Access Compliance Report

Public Rights-of-Way (Curb Ramps)

Intersection ID: 42729	Main Street: CALDWELL_FOREST_DR	Cross Street: COCHRAN_RIDGE_AV	Location:	E
ADA ID: 8E136CB7BCCF	Ramp Type: Perpendicular	Initial Pass/Fail: Fail	Overall Compliance: No	Severity Score: 10
Codes/Mitigation Info/Possible Solution		Field Measurements/Component Compliance

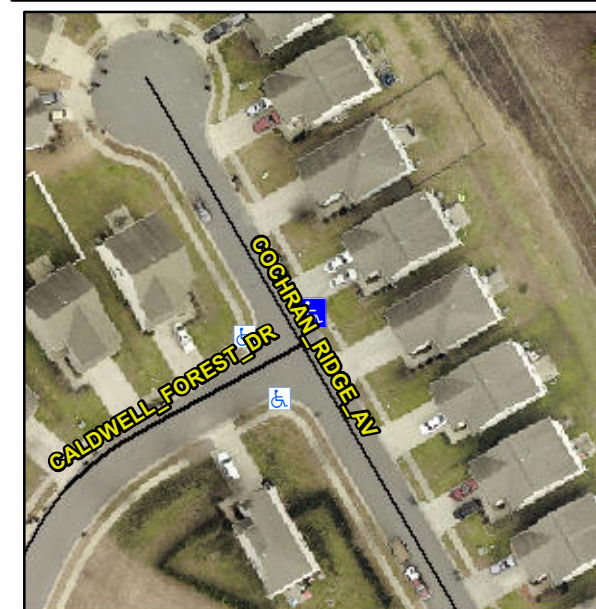
R304.5.1

Compliance	Description	Data	Compliance	Description	Data
N/A	Ramp Length (in)	46.0	Yes	Ramp Slope (%)	6.7
No	Ramp Width (in)	45.5	Yes	Ramp XSlope (%)	2.1
N/A	Flare Type LT	N/A	N/A	Flare Type RT	N/A
N/A	Flare Slope LT (%)	N/A	N/A	Flare Slope RT (%)	N/A
N/A	Flare Traversable LT?	N/A	N/A	Flare Traversable RT?	N/A
N/A	Landing Length (in)	N/A	N/A	DWS Provided?	N/A
N/A	Landing Width (in)	N/A	N/A	DWS Contrast?	N/A
N/A	Landing Slope (%)	N/A	N/A	DWS Length (in)	N/A
N/A	Landing X Slope (%)	N/A	N/A	DWS Full Width?	N/A
N/A	Landing Curb? (Y/N)	N/A	N/A	DWS Offset (in)	N/A
N/A	Shared Landing?	N/A			
N/A	Gutter Ponding?	N/A	N/A	Gutter Slope (%)	N/A
N/A	Gutter Lip Ht (in)	N/A	N/A	Gutter X Slope (%)	N/A
N/A	Painted X Walk1?	No	N/A	Painted X Walk2?	N/A
	X Walk 1 Direction	To W		X Walk 2 Direction	N/A
N/A	X Walk 1 Width (in)	N/A	N/A	X Walk 2 Width (in)	N/A
	X Walk 1 Slope (%)	3.5		X Walk 2 Slope (%)	N/A
	X Walk 1 X Slope (%)	2.3		X Walk 2 X Slope (%)	N/A

Remove & Replace Entire Ramp.
